Subject: **FLASHING IN A GRAY AREA WHEN
USING THE SDI INPUT (BKM-101C)**

Model: **BKM-101C**

Serial No: **2,000,001–2,003,217**

Figure 1

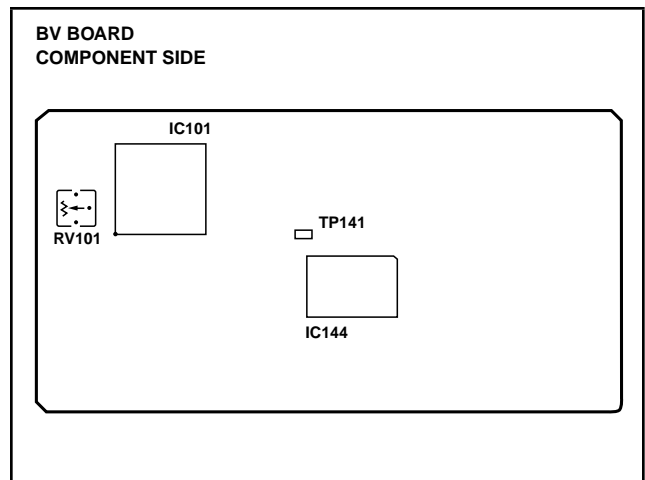
In some units, a flashing may occur in a grey area when a signal is input to the SDI terminal due to out of PLL free-run frequency. If this occurs, perform the following procedure.

BV Board, Component Side (See Figure 1.)

1. Connect a frequency counter to TP141 (zone F-6).
2. Turn on power and wait ten minutes.
3. Adjust RV101 (VCO ADJ) so that the frequency is $13.6\pm 0.1\text{MHz}$.
